MHBL response to:

Doris North Project - Natural Resources Canada (NRCan) Conformity Analysis of Final Environmental Impact Statement

WATER CONTENT RELATIVE TO TEMPERATURE IN SELECTED CONSTRUCTION MATERIALS

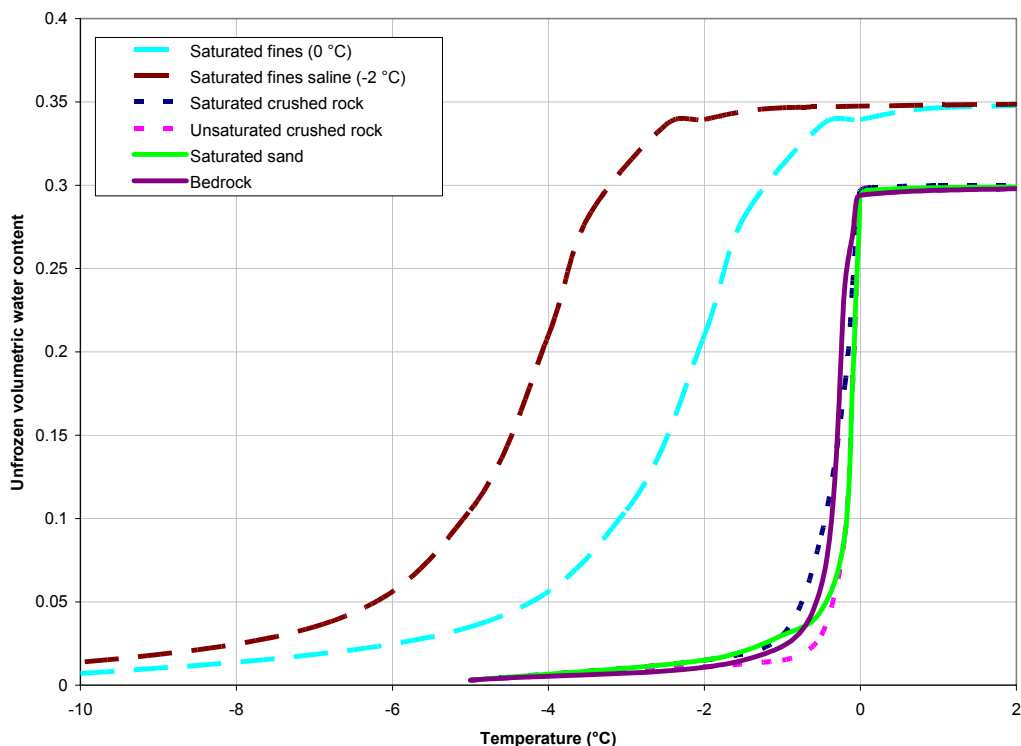
Some details of thermal modelling related to dam design are provided in SRK (2003 - A5) but further information is required. Variability in the thermal and physical properties of materials such as fine-grained marine sediment and till is not considered. Pore water salinity data indicates that the freezing point depression is -2 C but no information is provided on the relationship between unfrozen water content and temperature. Pore water will freeze over a range of temperature and significant amounts of unfrozen water will exist at temperatures below -2 C. The freezing characteristic curve is essential for the determination of thermal properties, hydraulic conductivity and strength properties of soils. Values for thermal properties are given for frozen and unfrozen state and there is no justification for these values. In addition, it is not clear if the variation in these properties with temperature and therefore unfrozen water content is considered or if pore water is considered to be bulk water.

MHBL comment:

Please see the figure showing unfrozen volumetric water content vs temperature below.
